# Access Compliance Report

## Public Rights-of-Way

Intersection ID: 3928	Main Street: BICKHAM_LN	Cross Street: KIRKGARD_TL	Location: SW
ADA ID: 119C69004148	Ramp Type: Directional1	Initial Pass/Fail: Fail	Overall Compliance: No
			Severity Score: 21.25

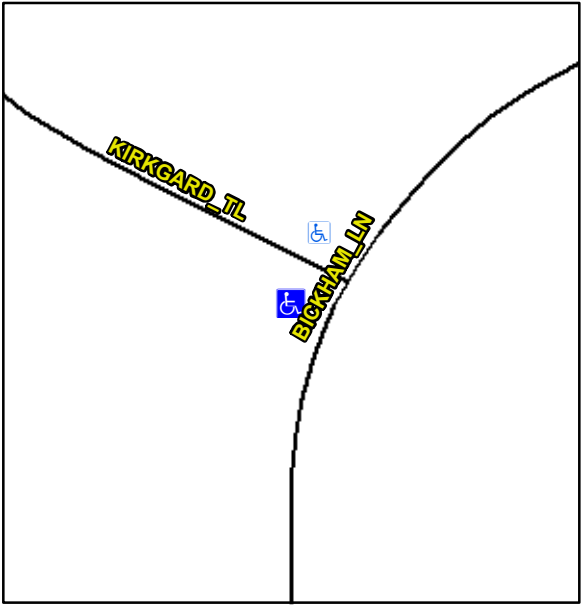
Codes/Mitigation Info/Possible Solution			Field Measurements/Component Compliance		
	Possible Solutions:		<b>Compliance</b>	<b>Description</b>	<b>Data</b>
	<b>Remove &amp; Replace Entire Ramp.</b>		<b>Compliance</b>	<b>Description</b>	<b>Data</b>
<p>Surveyor Notes:</p> <p><b>N/A</b></p> <p>PROW/ADA:</p> <p><b>R304.5.1, R304.2.2</b></p>			<b>N/A</b>	Ramp Length (in)	<b>63.0</b>
			<b>No</b>	Ramp Width (in)	<b>44.0</b>
			<b>No</b>	Ramp Slope (%)	<b>11.1</b>
			<b>Yes</b>	Ramp XSlope (%)	<b>0.9</b>
			<b>N/A</b>	Flare Type LT	<b>N/A</b>
			<b>N/A</b>	Flare Slope LT (%)	<b>N/A</b>
			<b>N/A</b>	Flare Traversable LT?	<b>N/A</b>
			<b>N/A</b>	Landing Length (in)	<b>0.0</b>
			<b>N/A</b>	Landing Width (in)	<b>0.0</b>
			<b>N/A</b>	Landing Slope (%)	<b>0.0</b>
			<b>N/A</b>	Landing X Slope (%)	<b>0.0</b>
			<b>N/A</b>	Landing Curb? (Y/N)	<b>N/A</b>
			<b>N/A</b>	Shared Landing?	<b>N/A</b>
			<b>N/A</b>	Gutter Ponding?	<b>0.0</b>

<b>N/A</b>	Gutter Lip Ht (in)	<b>0.0</b>
			<b>N/A</b>	Painted X Walk1?	<b>No</b>
				X Walk 1 Direction	<b>To N</b>
				X Walk 1 Width (in)	<b>N/A</b>
				X Walk 1 Slope (%)	<b>3.7</b>
				X Walk 1 X Slope (%)	<b>4.9</b>
			<b>N/A</b>	Ramp inside XWalk1?	<b>N/A</b>
			<b>N/A</b>	Any Obstructions?	<b>N/A</b>
				Obstruction Type	
			<b>Yes</b>	Surface Condition? (G/P)	<b>Good</b>
			<b>N/A</b>	Curb Slope (%)	<b>9.1</b>
Street 1 Name	KIRKGARD TL				
Stop Condition-Street 1	StopSign				
Street 2 Name	N/A				
Stop Condition-Street 2	N/A				
Total Cost:	\$	1600.00
